**Salem Earth
Products Inc.
Excavation**

**EASTERN CONNECTICUT
ENVIRONMENTAL REVIEW TEAM
REPORT**

Report Date: June 7, 1991

**Environmental Review Team
Report #491**

Topographic Map
Scale 1" = 1000'

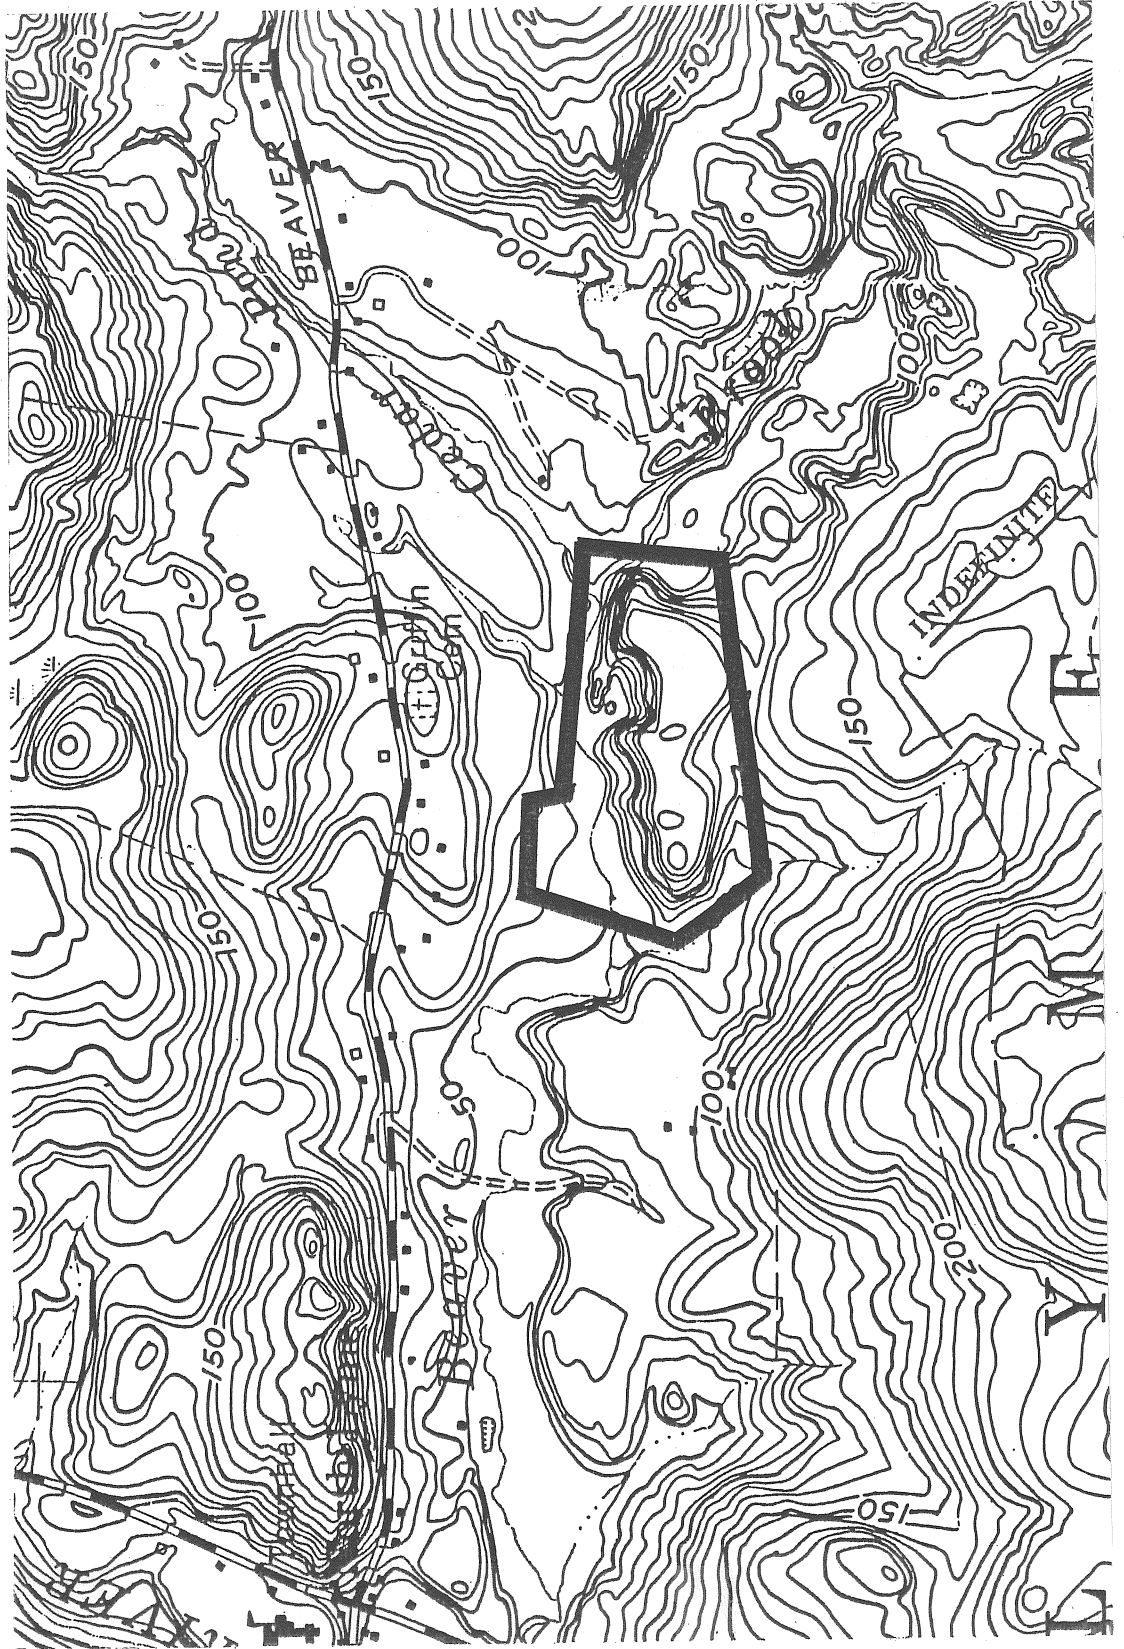
The stratified drift deposit is a flat-topped ridge 1900 feet long, 500 feet in width and 70 feet in height covering approximately 27 acres. Exploratory pits along the ridge crest expose coarse clean well sorted gravel composed of pebbles and small boulders of the various gneisses which make up the bedrock in the immediately surrounding area. The gravel is very porous and permeable and as a result the water table under the ridge is fairly deep (10's of feet). Indeed, a small 15 foot deep kettle (for some reason not shown on the detailed

topographic survey supplied by Salem Earth Products) at the eastern end of the ridge shows no evidence of intersecting the local water table. Cuts along the southern gravel access road suggest the coarseness of the material decreases towards the bottom of the ridge. A small borrow pit at the base of the hill is dug into silt sized material. Although this may have been material which was washed down the steep slope, or was transported by wind before a protective vegetation cover was established after the ice disappeared, it may suggest that some portions of the ridge may not be worth excavating.

by Salem Earth Products assume the entire ridge is composed of saleable material. However, only gravel on the ridge crest has been tested and there is some indication that the deposit becomes finer grained at lower levels. It would be prudent therefore, if Salem Earth Products was required to explore the full potential of the deposit prior to embarking on the project. A series of small pits on the flanks of the ridge would better define the likely extent of the future excavation. In the absence of this information Salem Earth Products should be asked how they propose to leave the site if they are forced to abandon the project at an intermediate stage? ■

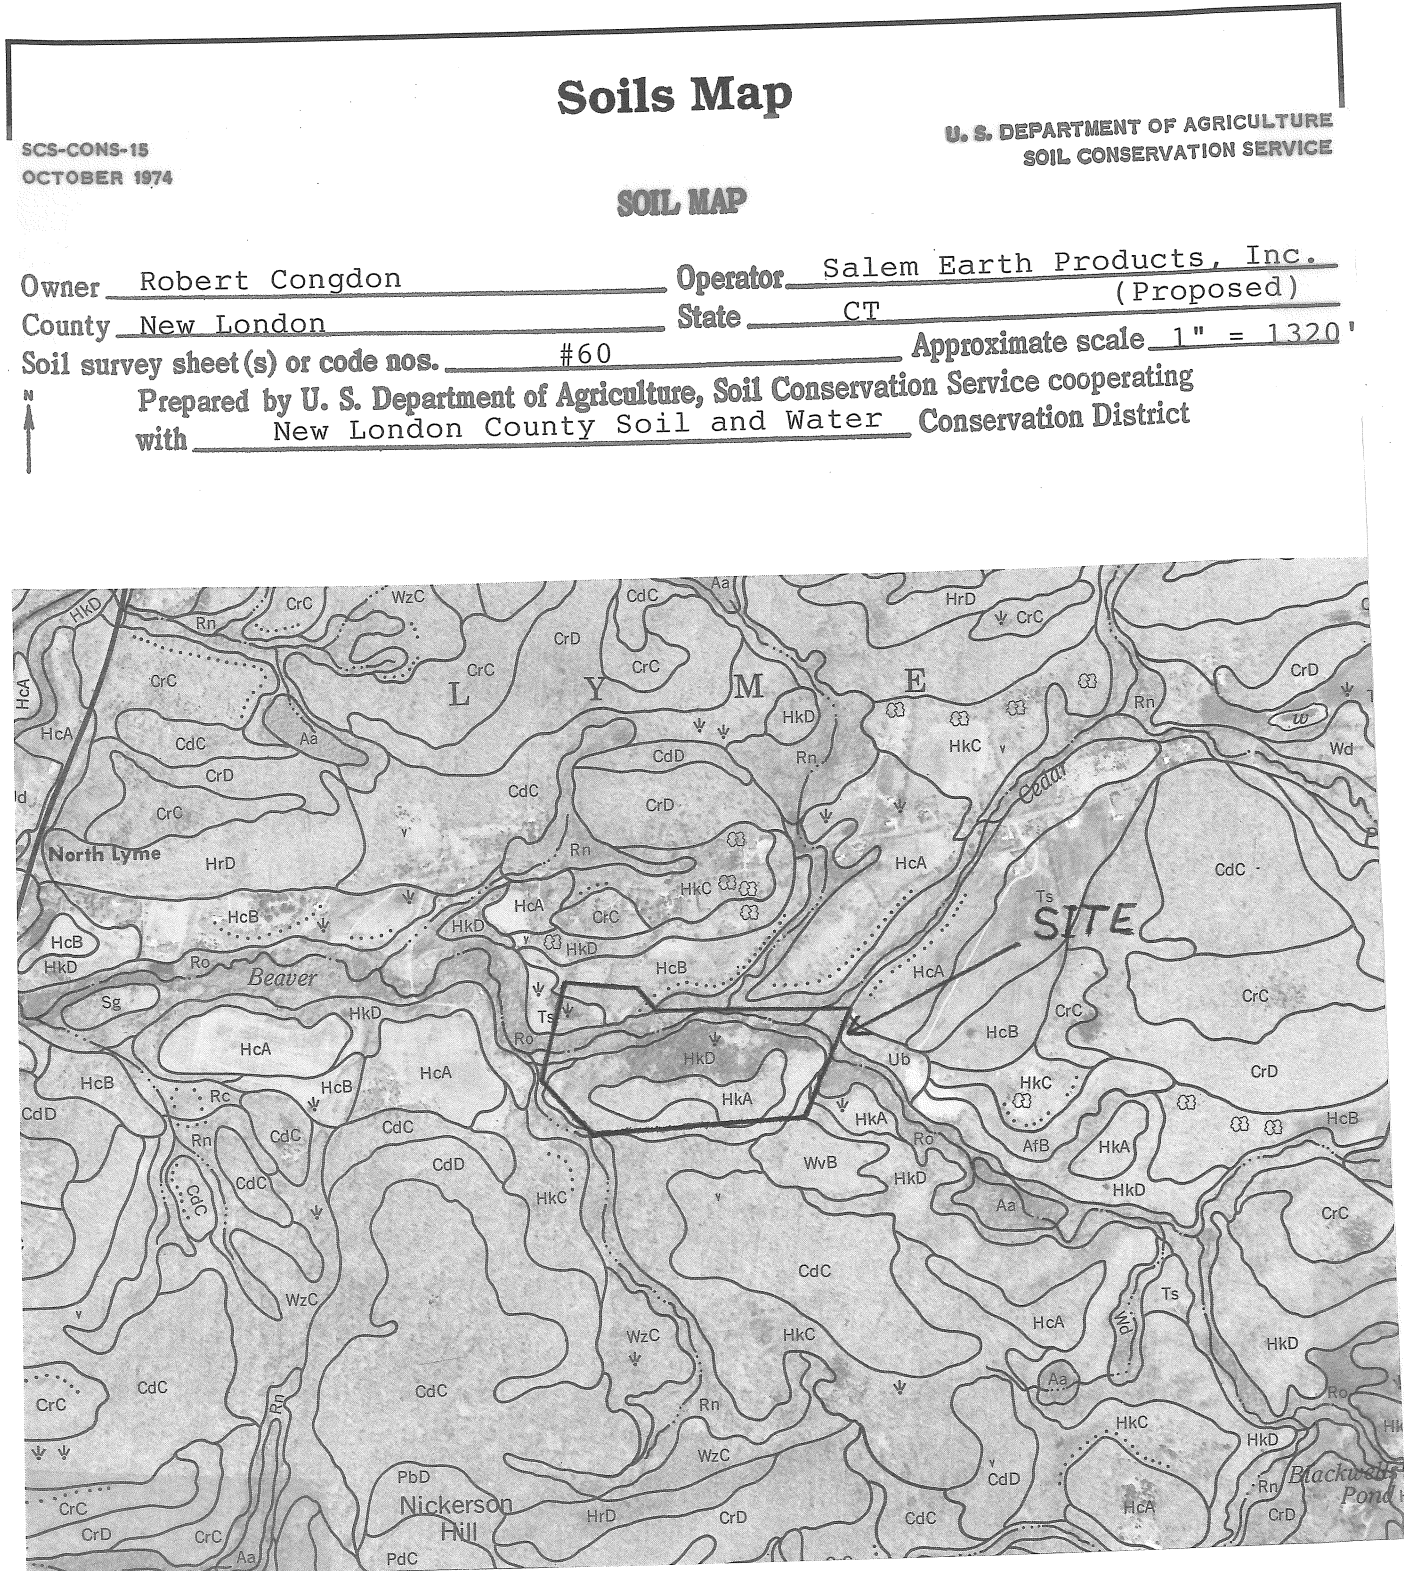
The primary soil type in the area of proposed activity is Hinckley gravelly sandy loam (see soils map). The soils along Beaver Brook are mapped as Rippowam fine sandy loam, a wetland soil. Additional soil series are Haven silt loam and Tisbury silt loam. Soil series descriptions are as follows:

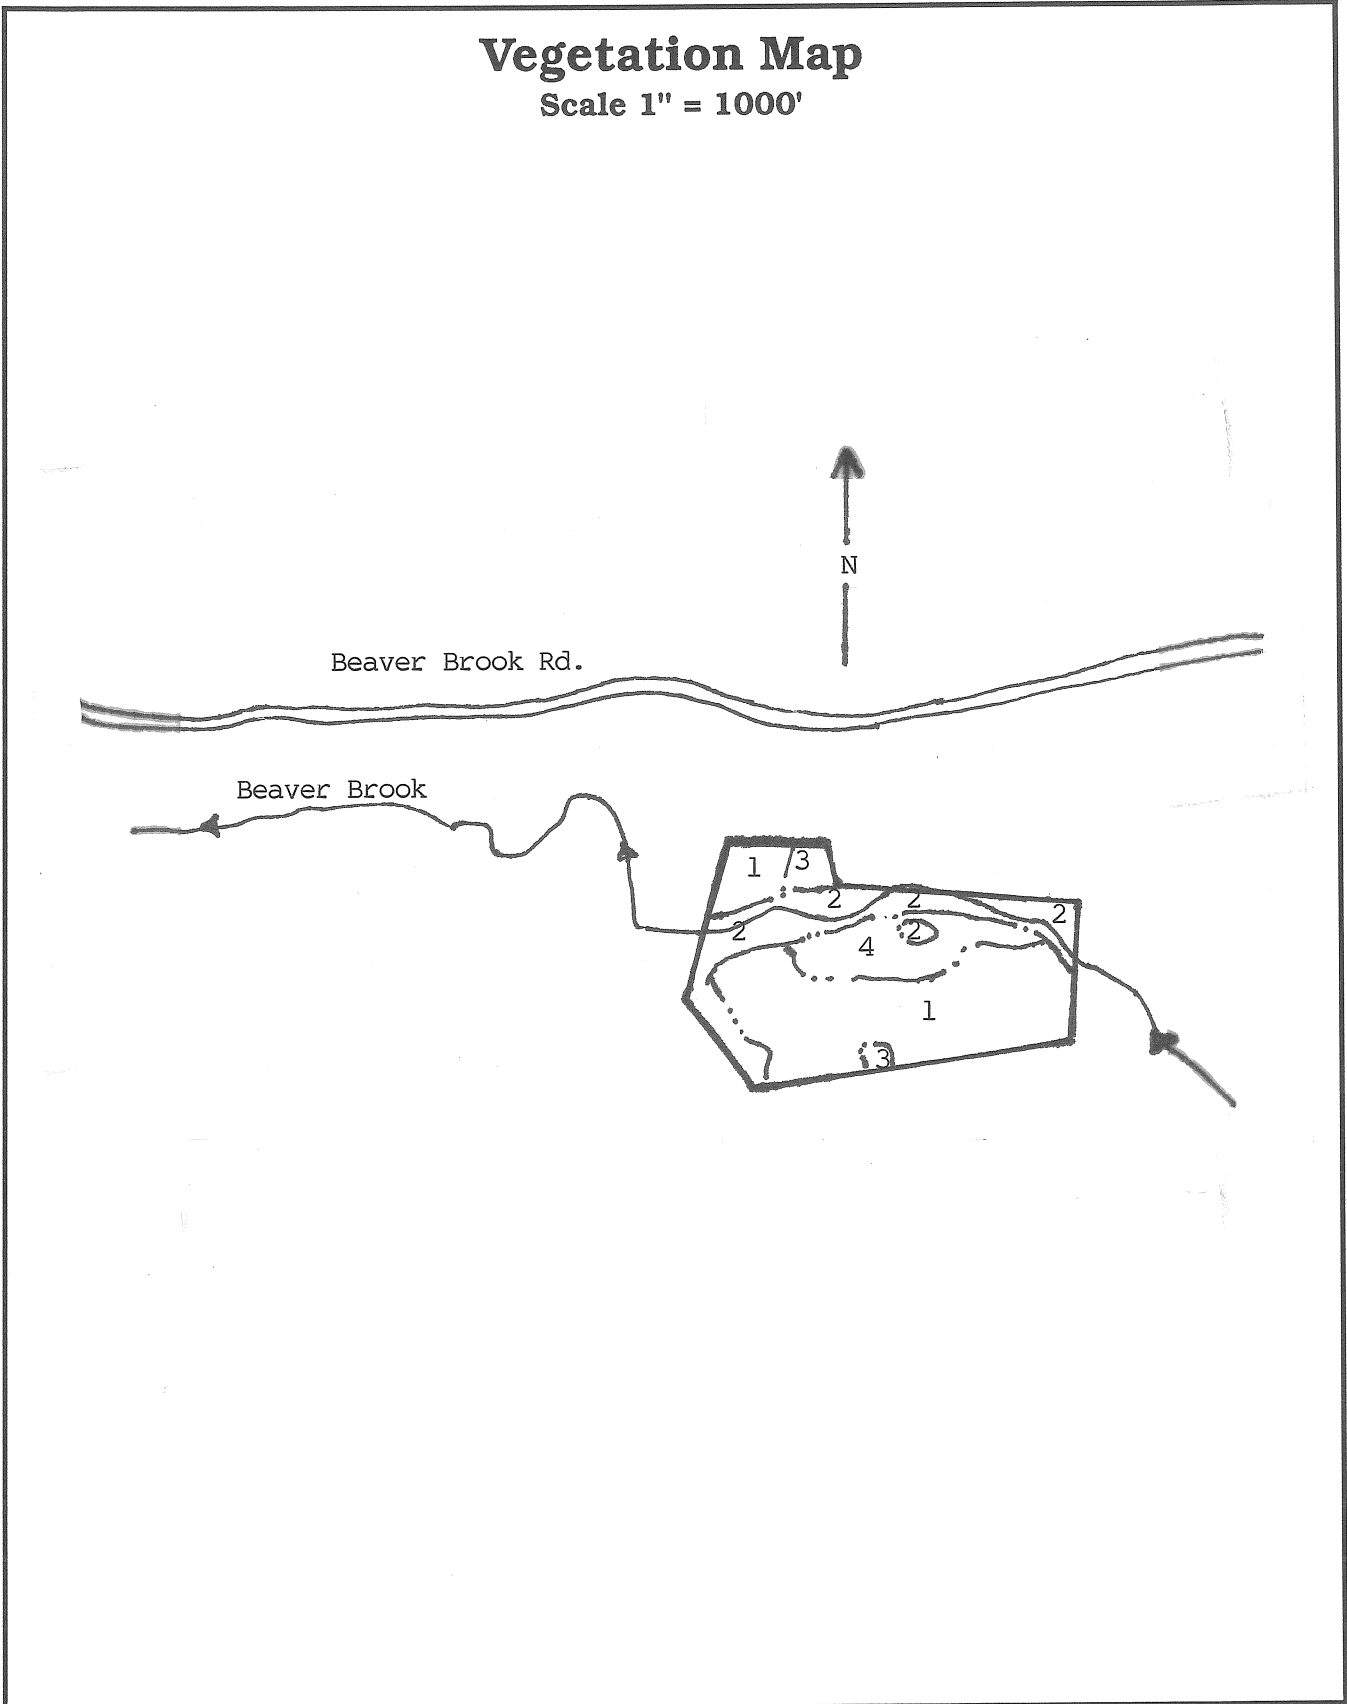
The greatest erosion potential that can be associated with the clearing of forest vegetation is in Stand 4 where the slopes reach a 70% grade. The unrestricted removal of all forest vegetation with logging equipment on very steep and erodible Hinckly soils will probably result in significant disturbance of the litter layer. In order to minimize the erosion potential associated with the removal of forest vegetation, the following is recommended:

The clearing of forest vegetation (both cutting and removal) in Stand 4 should be done in a multiple step operation where one section at a time is cleared. The sections should be parallel to the contours. The first section should be at the top of the slope and only extend downslope far enough to accommodate the excavating of the first 10 foot lift. Subsequent sections for clearing should progress downslope only as fast as needed to accommodate subsequent 10 foot lifts. This will minimize the amount of slope exposed at a given
